Re: Acacia
229 W. Lakelawn Place
201 W. Lakelawn Place

The attached information is being submitted for an informational presentation to the Urban Design Commission on the November 19, 2008, agenda.

We have had an information neighborhood meeting and preliminary meeting with Landmarks and Zoning. As a result of these meeting revisions have been made to the original plans. These revisions are reflected on elevation sheet 5.1, which is labeled "Revised Elevations 11-11-08."

REVISED ELEVATIONS 11-11-08

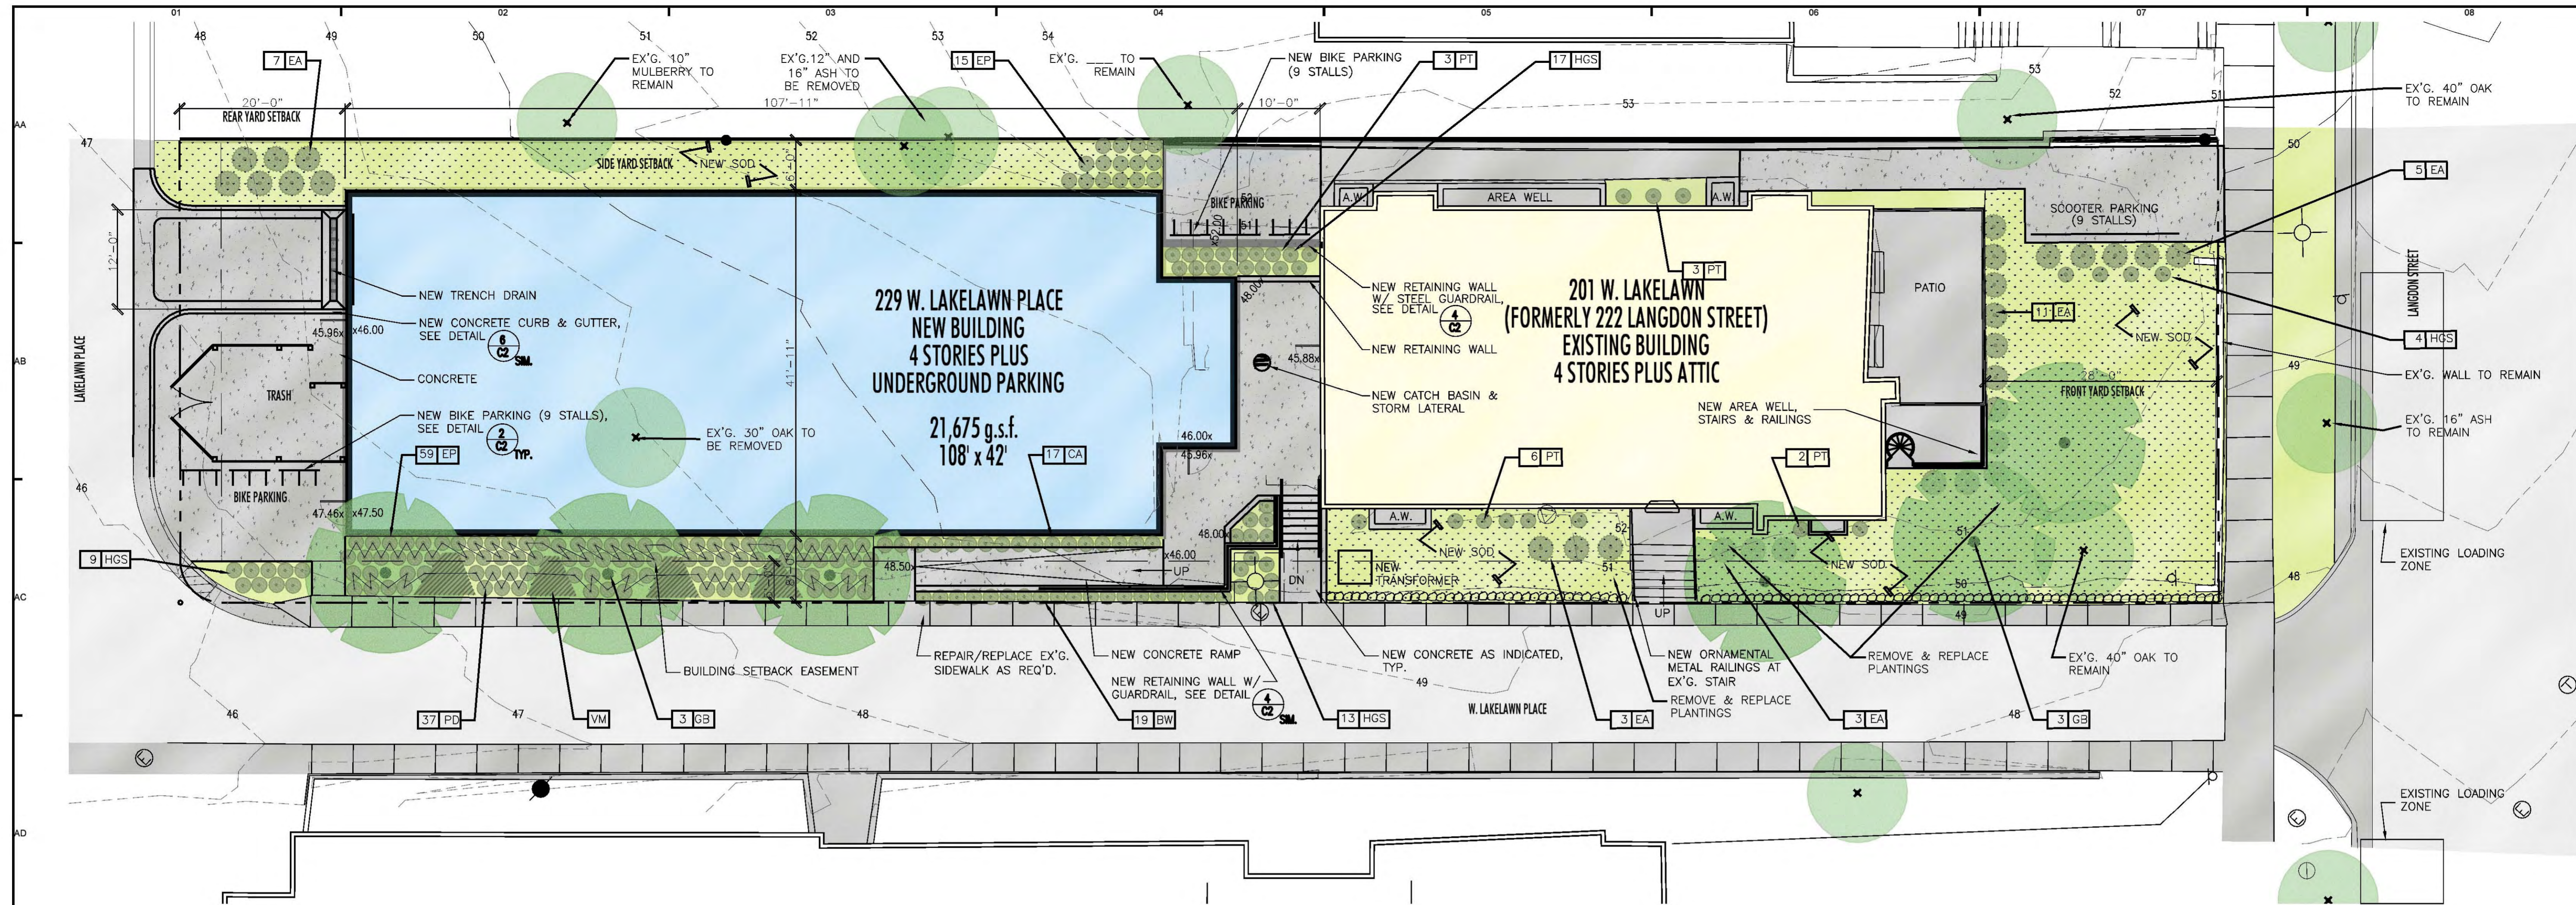
These revision include larger first story windows, change in poured concrete base detail, decreasing amount of EIFS, increasing the amount of masonry, revising masonry material from burnished block to brick, a more prominent entrance with larger canopy, more glass and signage.
